Public Comments Agenda Item 9

Written Comments Received By 12pm on 3/14/2022

This email is on behalf of neighbors surrounding the property at TBD Olympian Way. We have appealed the Planning Commission Decision CDP-430-21, File NO 2021-018 and will be before you on March 14 to discuss the appeal.

GEOTECHNICAL REPONSE TO KASUNICH LETTER

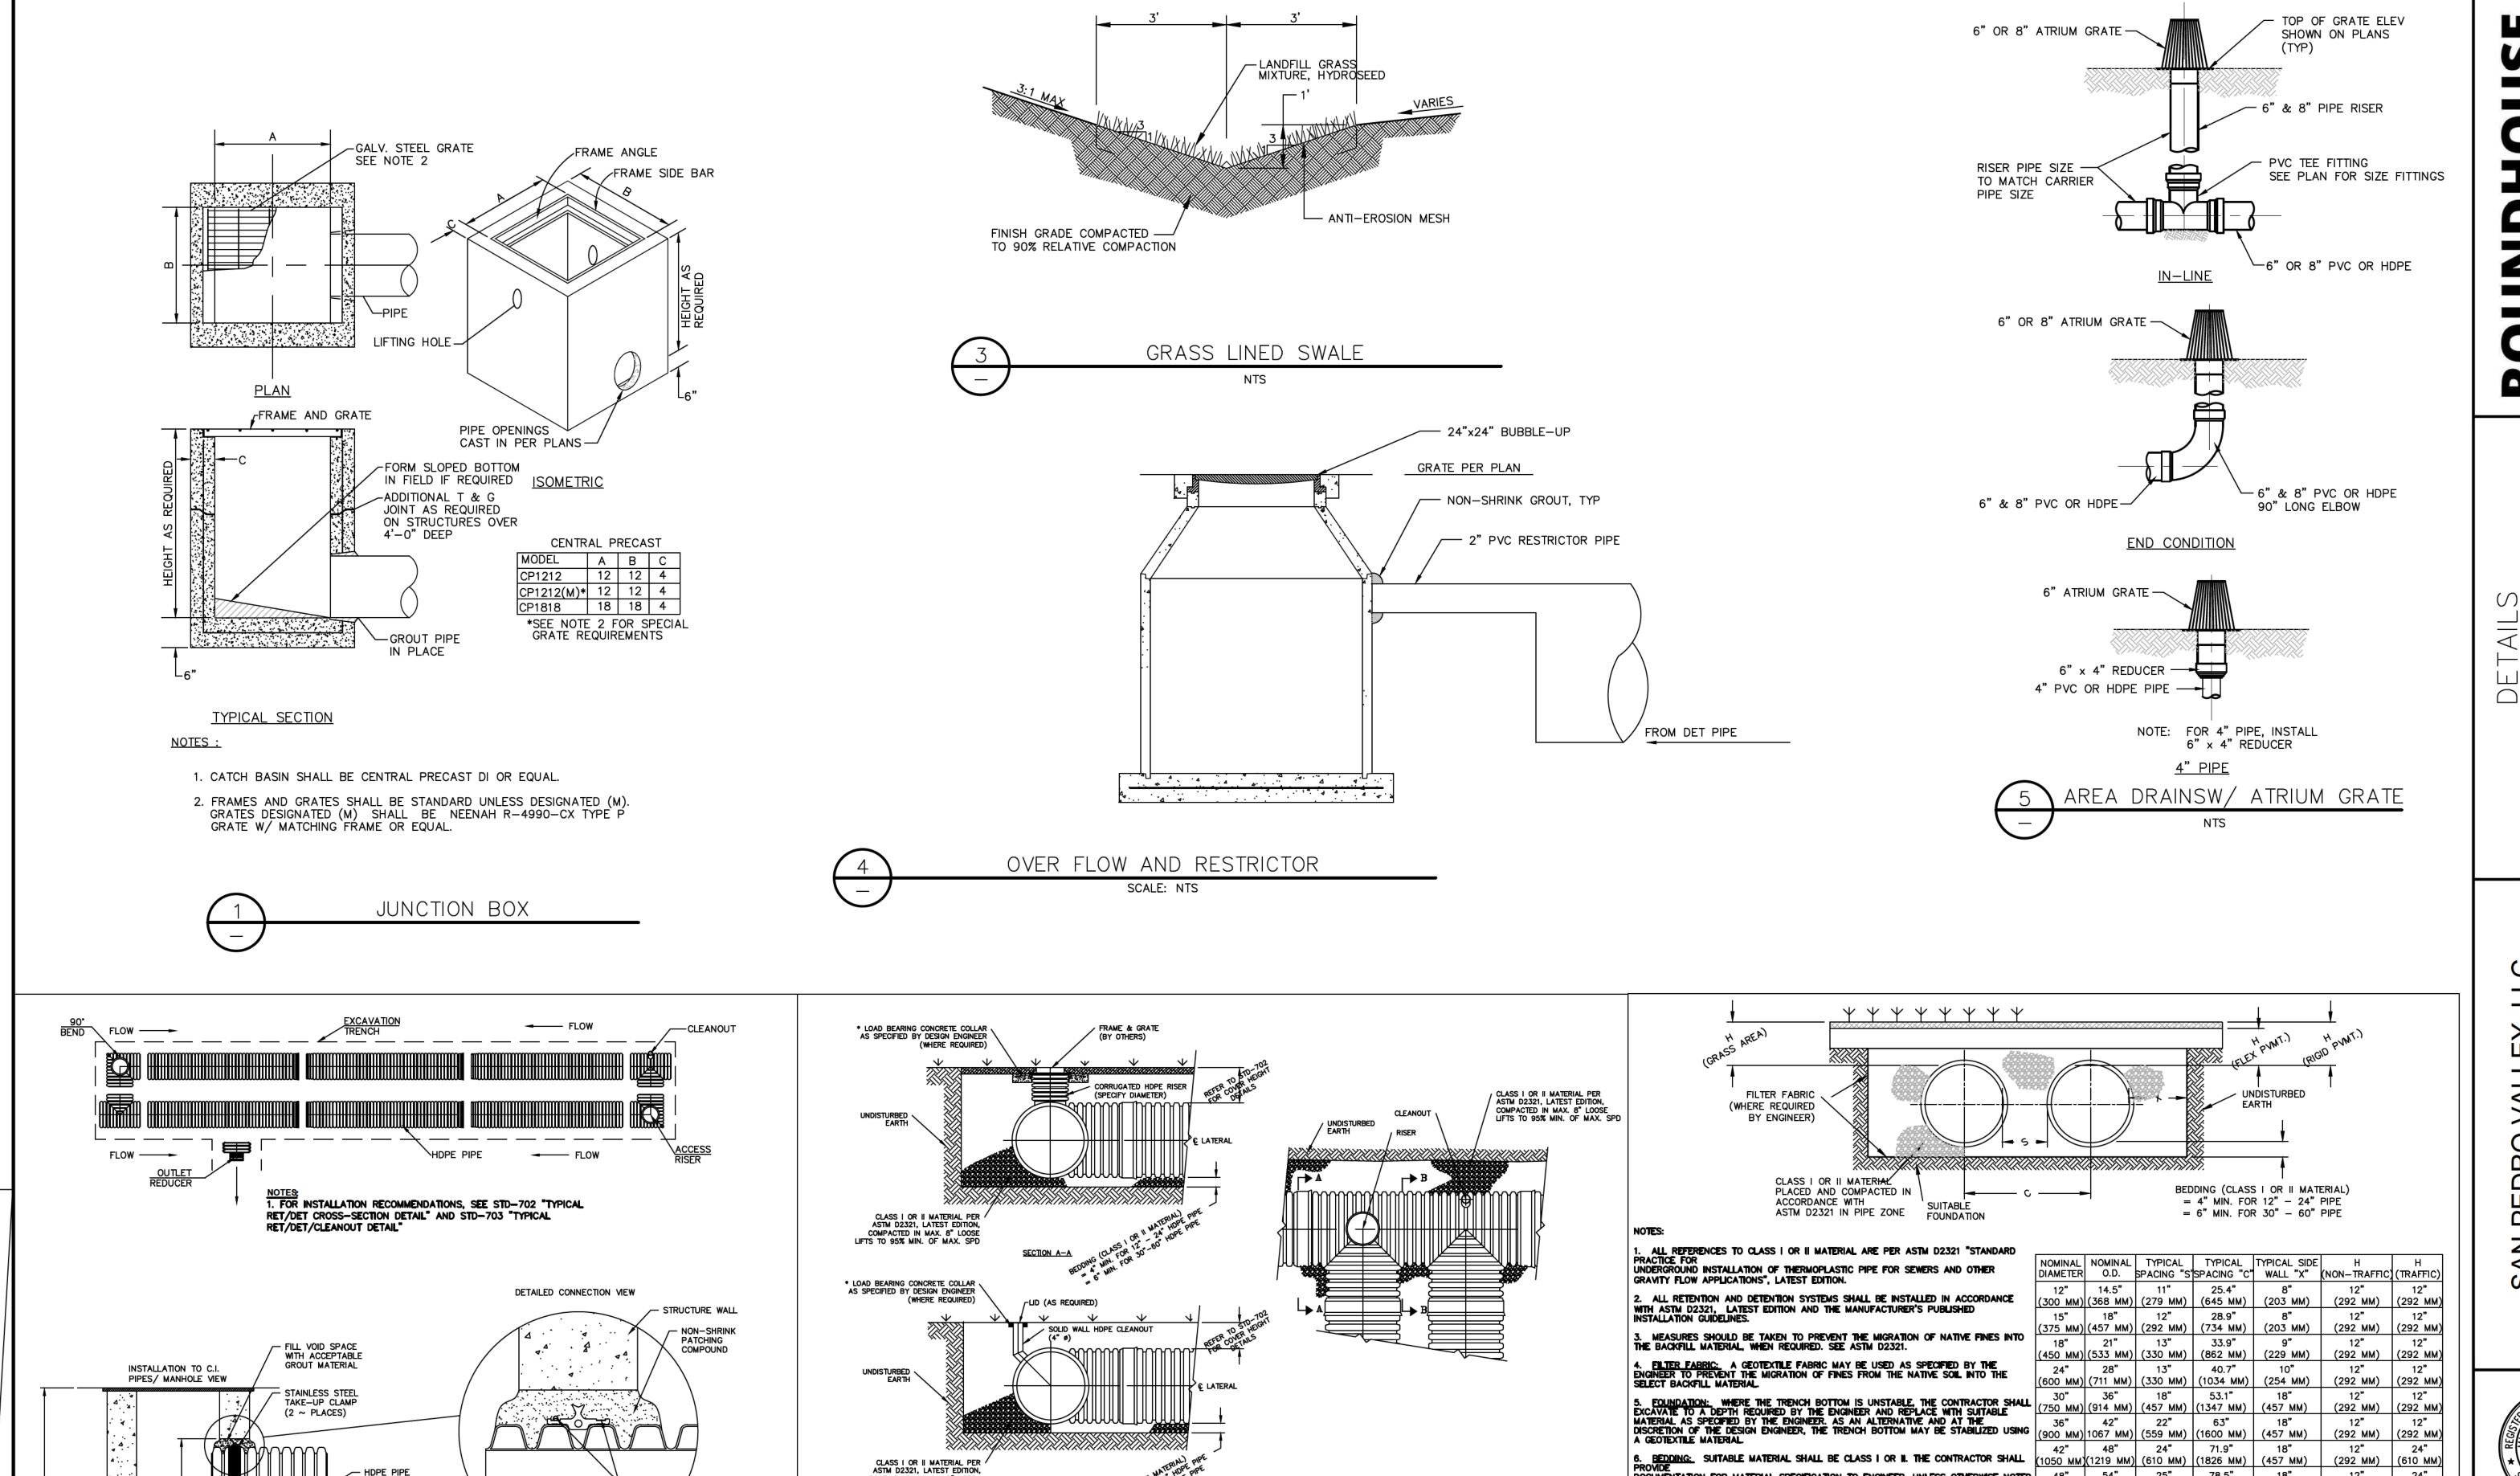
The following drainage recommendations were presented on Page 13 in the Project Geotechnical Report and HAVE NOT been adhered to in the proposed development plans:

- 1. Accumulated drainage should be discharged minimum 15 feet away from the house, PREFERABLY (emphasis added) at the street.
- A percolation style dissipation system is NOT PERMITTED (emphasis added) for use at this site.

While the detention system uses non-perforated detention piping, the junction box (Detail 1 on Sheet 3.1) does have a small percolation weep hole at its base to permit the box to drain after rainfall events. While we consider this to be a very minor amount of likely water to percolate into the soils, we are requesting that this small gravel weep hole be removed from the plans. This will address the concerns expressed by Mr. Kasunich, thereby providing a fully contained detention system and alleviating the need for a seismic slope stability analysis of the upper hillside soils.

See attached letter from Geoforensics. We have removed any perforations from the drainage system which should address the appellants' concerns. The revised civil plans are attached. It should be noted for the record that the design was completed in accordance with the city drainage policy, which does allow infiltration (dry wells). The discharge point has always been 16' away from the house.
